SERVICE BULLETIN

MODEL: IC-R7000 SN AFFECTED: ALL BULLETIN # 35187-001

SUBJECT: **SUPERSEDES SB# 32787-001 (11/25/87)** PROBLEM: AUDIO OUTPUT BECOMES

R-7000 IF Board

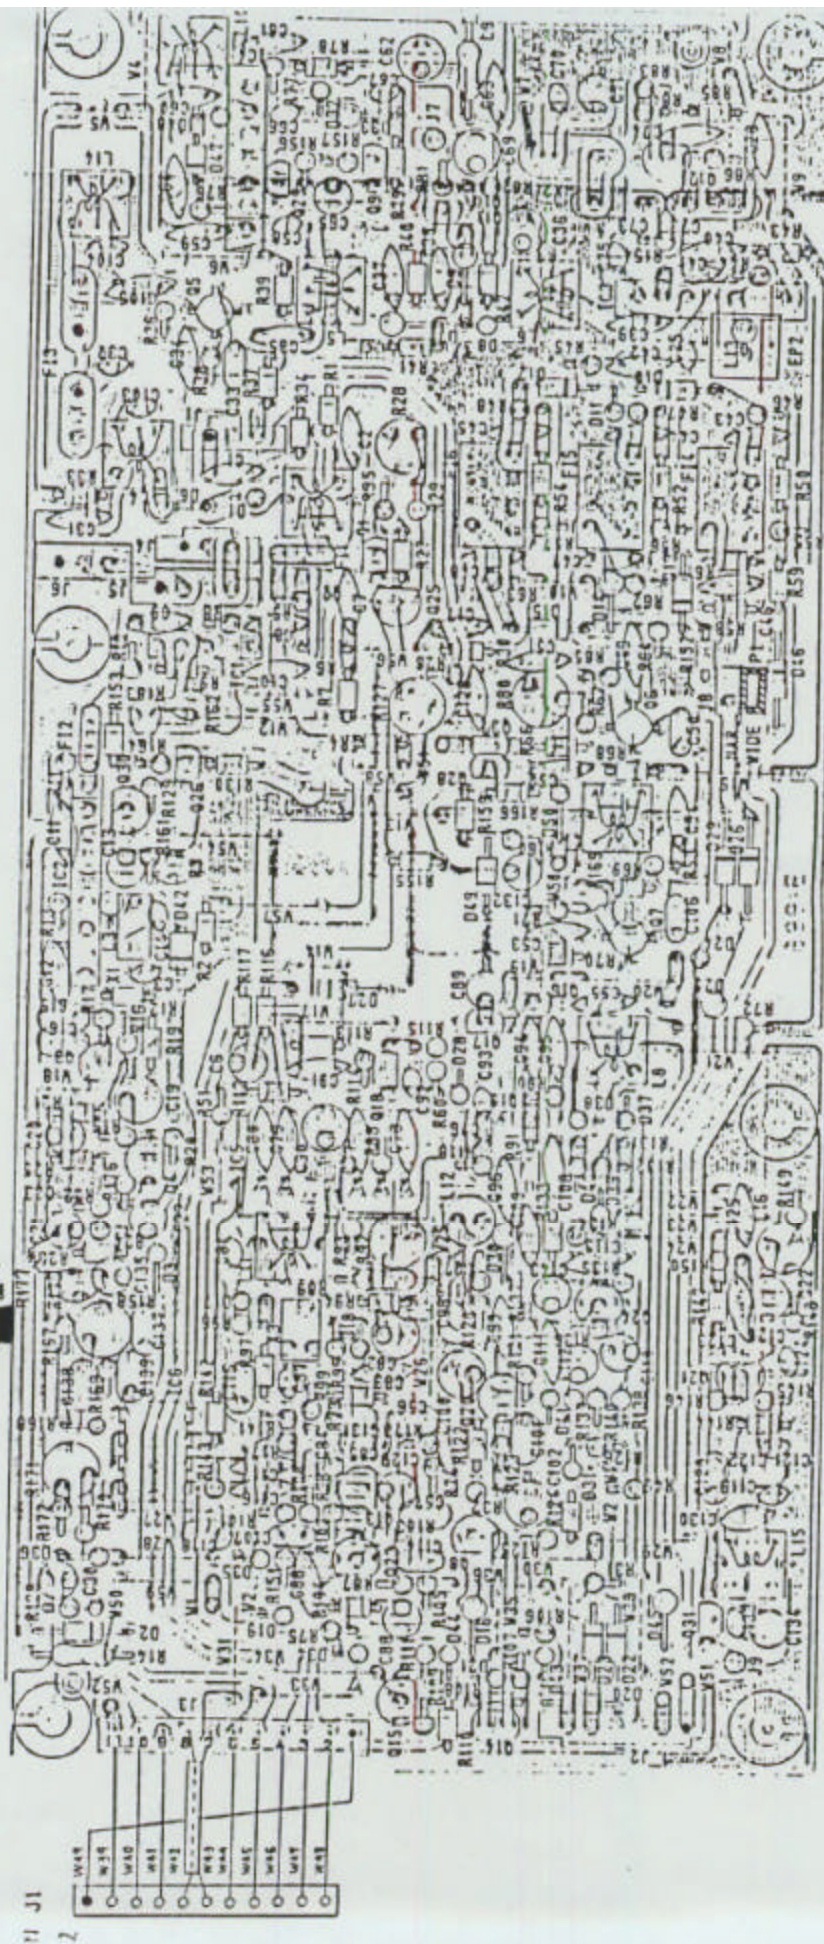
Add R-177
at this
point on the
foil side

PARTS EFFECTED	COMPONENT IDENTIFIER	BOARD OR UNIT	CHANGE TO
NEW PART	(NEW) R-177	I.F.	ADD NEW RESISTOR (100 K Ohms 1/4w) I/A PART # 915-01187

1. REMOVE THE TOP COVER AND DISCONNECT AND REMOVE MAIN I.F. BOARD.
2. ADD R-177 (P/N 915-01187 100 K) TO THE POINT SHOWN ON DIAGRAM 1 (FOIL SIDE)
3. RE-INSTALL BOARD AND TEST IT. REPLACE COVERS AND WARM UP FOR A MINIMUM OF TWO HOURS IN ORDER TO CHECK FOR DISTORTED AUDIO.
4. RETURN TO SERVICE
